Access Compliance Report

Public Rights-of-Way

Intersection ID: 10034489	Main Street: PINEBURR_RD	Cross Street: N/A	Location: SE
ADA ID: BB34EC567F6B	Ramp Type: BlendTrans2	Initial Pass/Fail: Pass	Overall Compliance: No
			Severity Score: 10.25

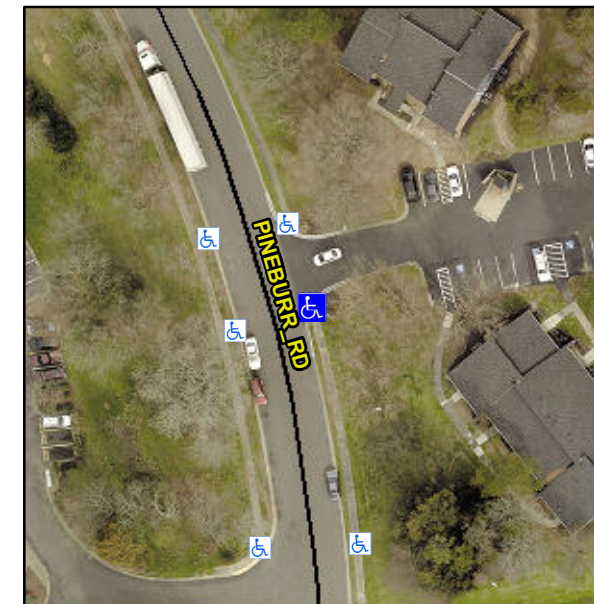
Not Found, R304.5.3, R305

Compliance	Description	Data	Compliance	Description	Data
N/A	Ramp Length (in)	40.0	Yes	BlendTrans Slope (%)	3.4
Yes	Ramp Width (in)	48.0	No	BlendTrans XSlope (%)	4.0
N/A	Flare Type LT	None	N/A	Flare Type RT	None
N/A	Flare Slope LT (%)	N/A	N/A	Flare Slope RT (%)	N/A
N/A	Flare Traversable LT?	N/A	N/A	Flare Traversable RT?	N/A
N/A	Landing Length (in)	N/A	No	DWS Provided?	No
N/A	Landing Width (in)	N/A	N/A	DWS Contrast?	No
N/A	Landing Slope (%)	N/A	N/A	DWS Length (in)	N/A
N/A	Landing X Slope (%)	N/A	N/A	DWS Full Width?	No
N/A	Landing Curb? (Y/N)	No	N/A	DWS Offset (in)	N/A
N/A	Shared Landing?	No			
Yes	Gutter Ponding?	No	Yes	Gutter Slope (%)	0.8
Yes	Gutter Lip Ht (in)	0.0	Yes	Gutter X Slope (%)	1.9
N/A	Painted X Walk1?	No	N/A	Painted X Walk2?	No
	X Walk 1 Direction	To N		X Walk 2 Direction	To W
	X Walk 1 Width (in)	N/A		X Walk 2 Width (in)	N/A
	X Walk 1 Slope (%)	1.5		X Walk 2 Slope (%)	1.3
	X Walk 1 X Slope (%)	5.5		X Walk 2 X Slope (%)	1.3

Remove & Replace Curb Ramp With Two New Directional Ramps or Equivalent.
